Project	IEEE 802.16 Broadband Wireless Access Working Group < http://ieee802.org/16 >	
Title	Flow charts for MS Initial Ranging with Non-transparent RS (Centralized)	
Date Submitted	2007-07-05	
Source(s)	Kanchei (Ken) Loa, Yi-Hsueh Tsai, Yung-Ting Lee, Hua-Chiang Yin, Shiann-Tsong Sheu, Youn-Tai Lee, Institute for Information Industry 8F, No. 218, Sec. 2, Dunhua S. Rd., Taipei City 106, Taiwan	Voice: +886-2-27399616 Fax: +886-2-23782328 loa@nmi.iii.org.tw
Re:	IEEE 802.16j-07/019: "Call for Technical Comments Regarding IEEE Project 802.16j"	
Abstract	This contribution proposes flow charts for MS Initial Ranging with Non-transparent RS	
Purpose	Text proposal for 802.16j Baseline Document.	
Notice	<i>This document does not represent the agreed views of the IEEE 802.16 Working Group or any of its subgroups. It represents only the views of the participants listed in the "Source(s)" field above. It is offered as a basis for discussion. It is not binding on the contributor(s), who reserve(s) the right to add, amend or withdraw material contained herein.</i>

Flow charts for MS Initial Ranging with Non-transparent RS

Figure 95e Handle CDMA Initial Ranging Code at Non-transparent RS (Part 1)

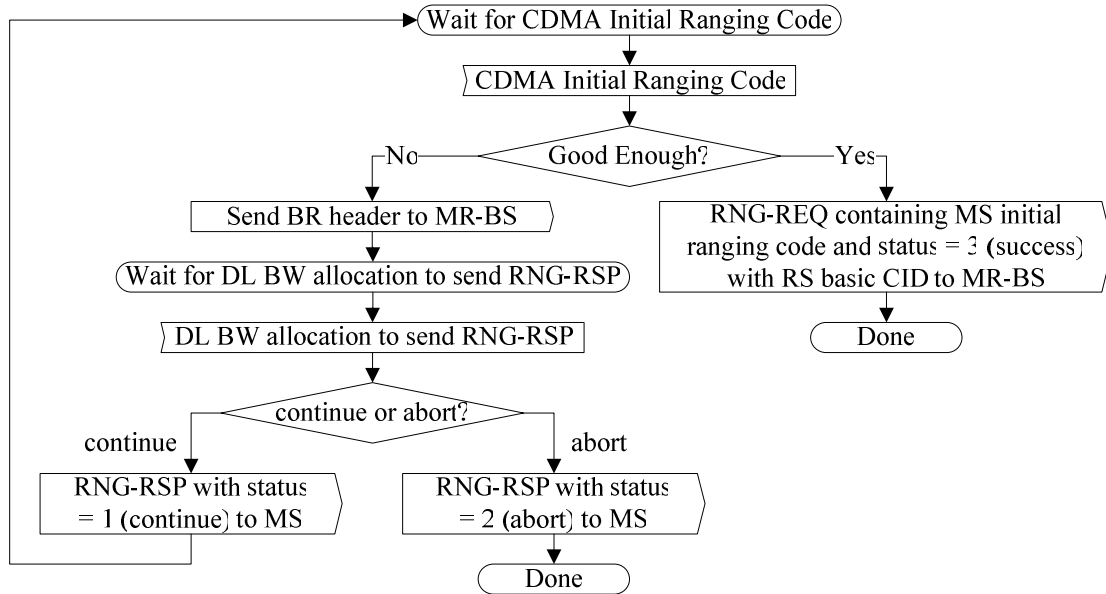
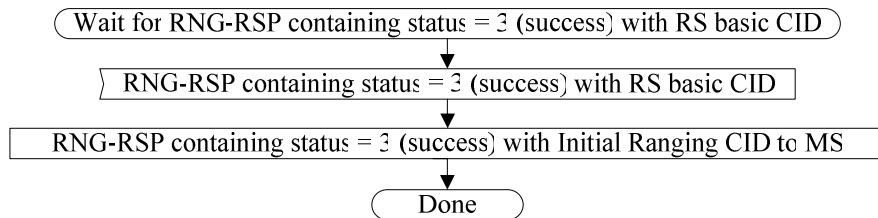
[Insert the following figures at the end of subclause 6.3.9.16.2.1:]
